APPEAL SUMMARY

Appeal ID: 31977	Project Address: 4626 SE Clinton Street
Hearing Date: 11/15/23	Appellant Name: Tanya Wuertz
Case No.: B-008	Appellant Phone: 303.883.8309
Appeal Type: Building	Plans Examiner/Inspector: Chanel Horn
Project Type: Commercial	Stories: 3 Occupancy: Group R-2 Construction Type: Type V-A
Building/Business Name: Peaceful Villa - Clinton Street Building West	Fire Sprinklers: Yes - as required per NFPA 13
Appeal Involves: Erection of a new structure, Reconsideration of appeal	LUR or Permit Application No.: 23-035595-CO
Plan Submitted Option: pdf [File 1] [File 2]	Proposed use: Residential Apartments

RECONSIDERATION TEXT: The purpose of this appeal is to allow two mailbox units to be located as shown under the exterior exit stairway in the west breezeway of the Clinton West Building.

Location of two mailbox units within the exterior exit stairway of the Clinton West Building: Granted as proposed.

FIRST FLOOR PLAN
SECTOR A

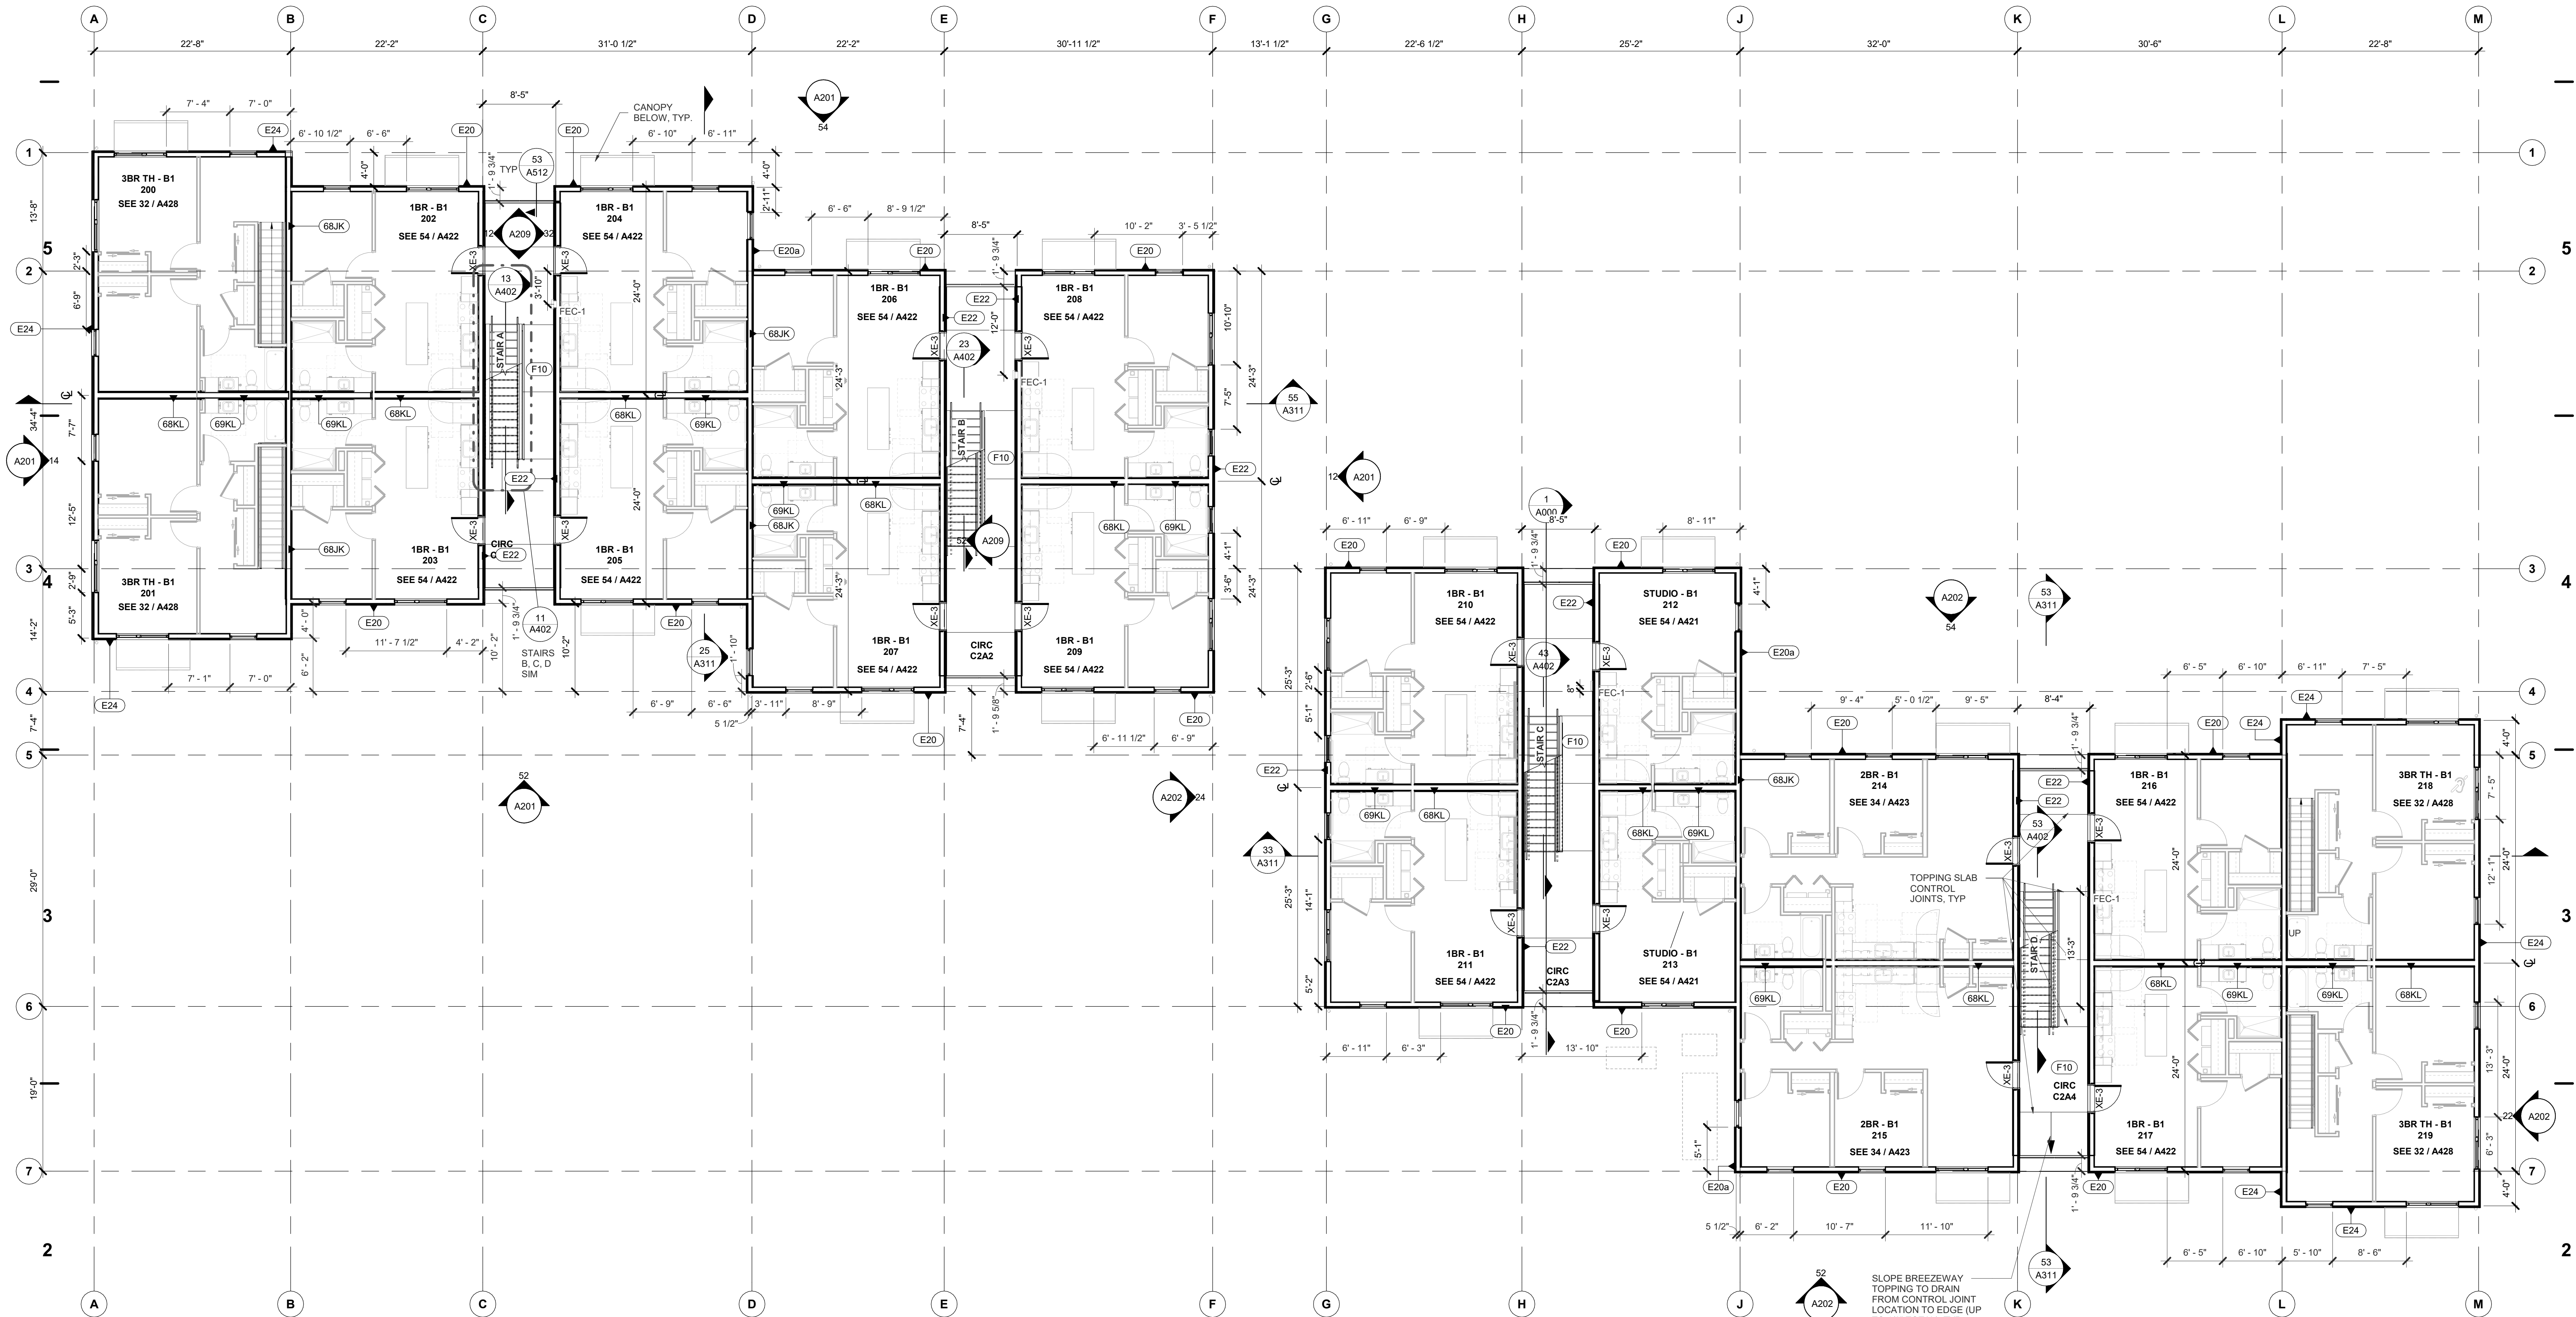
Mailboxes (typical of two, located side by side)

— Each mailbox unit is 30.5 inches wide x 18 inches deep x 62 inches high (see attached cutsheet).

— Located outside of plan area footprint of physical stair, including landing depth.

1 SECTION - CLINTON EAST - BREEZEWAY AT BIKE RM & LAUNDRY RM
1/4" = 1'-0"

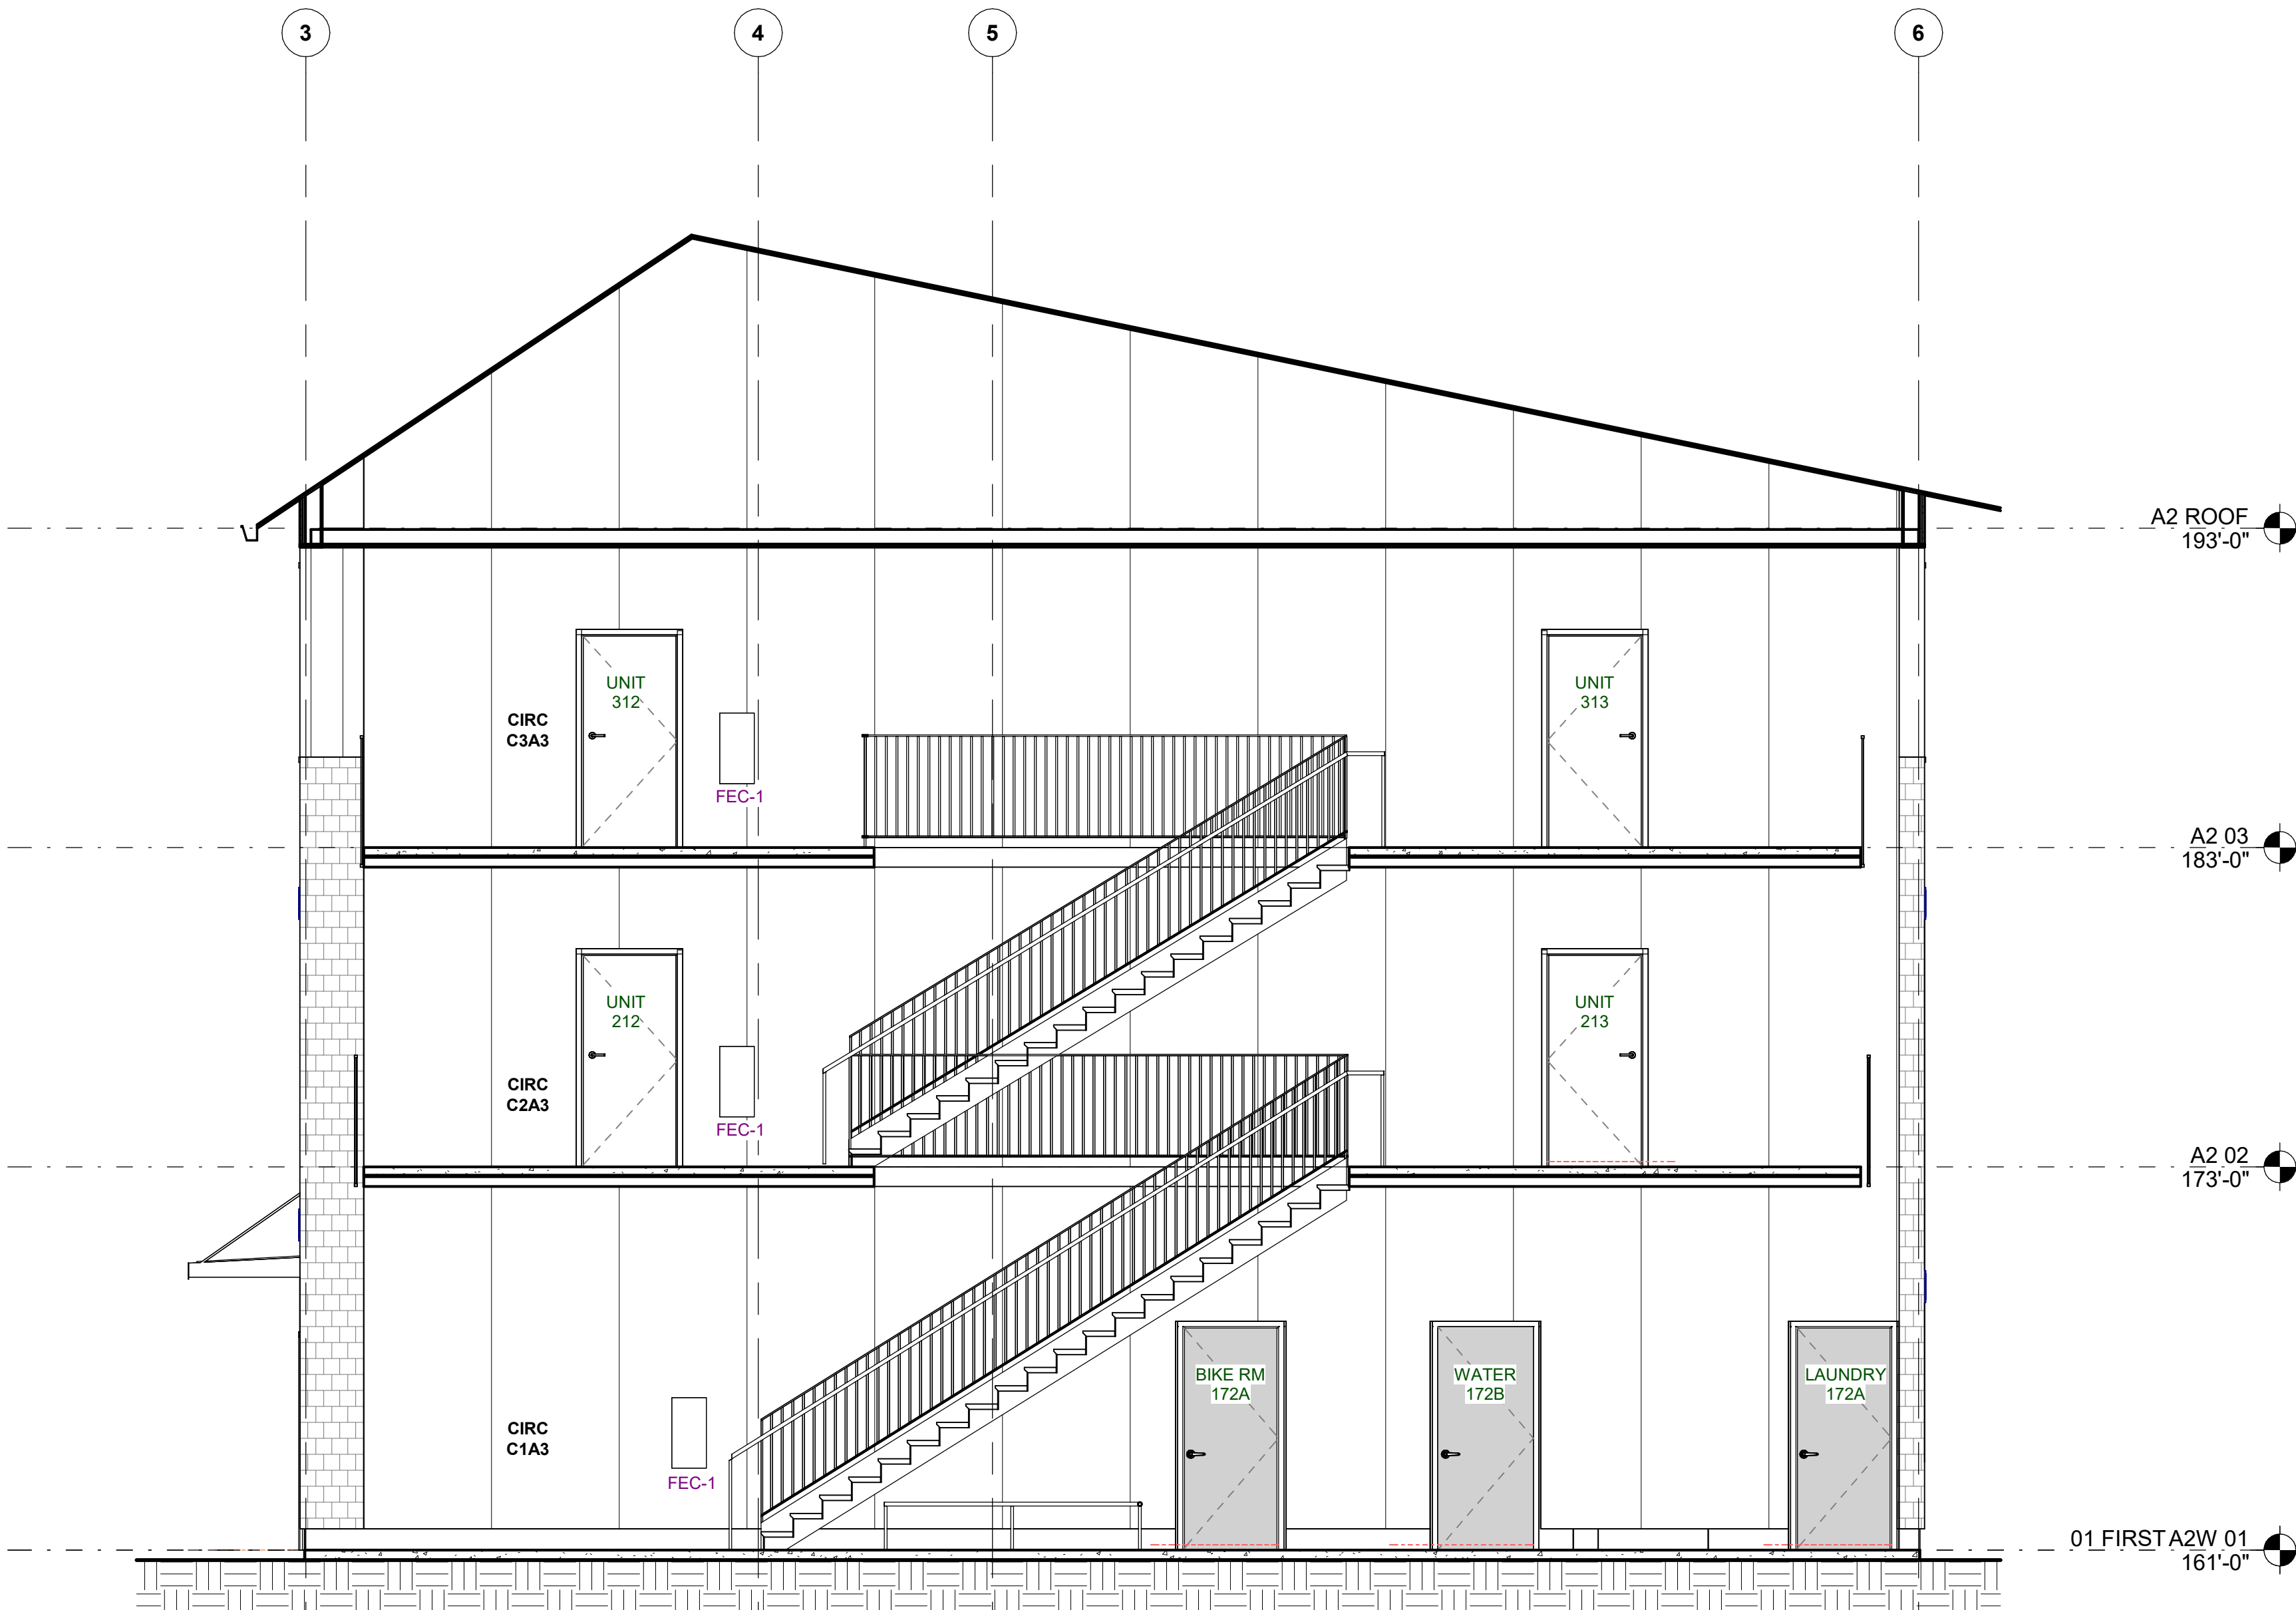
The 90-min person-doors at the Trash Room, Bike Room, and Laundry Room will be provided with digital access control and an auto-actuator for accessible access, as well as automatic, self-closing hardware. This will prevent the door from being propped-open and ensure it is closed during a fire/smoke event. Additionally, a vision panel will aid in viewing potential smoke and fire, which will inform someone of the risk before opening the door during an event that would allow fire/smoke into the breezeway. For the most significant rooms in terms of fire origination risk, the Trash Room and Laundry Room doors are at the far south end of the breezeway. At the Laundry Room, the door is outside the landing plus 10 ft requirement per Section 1027.6; at the Trash Room, it is less than 6 inches shy of meeting this requirement.

At the Trash Room, Bike Room, and Laundry Room, an additional sprinkler head will be provided at the interior of the room, above the door. Designed as a "water curtain" per NFPA 13, it will suppress any fire that originates within the room, thus protecting the opening beyond the increased fire-resistance rating of the door. As well, one (1) 135-degree heat detector will be provided in each room. This will be tied to the notification appliances (horns and strobes) that are provided as required in each unit; additionally, a fire alarm notification appliance will also be provided at each breezeway where these openings occur. This early warning detection will allow occupants to be alerted earlier than normal to initiate egress; it provides a trigger at 135 degrees, as opposed to the 155 degrees required to fuse a sprinkler head. Additionally, if triggered at the same time, the heat detector provides notification 30-90 seconds before the fire sprinkler water flow device due to the inherent delay with flow switch verification.
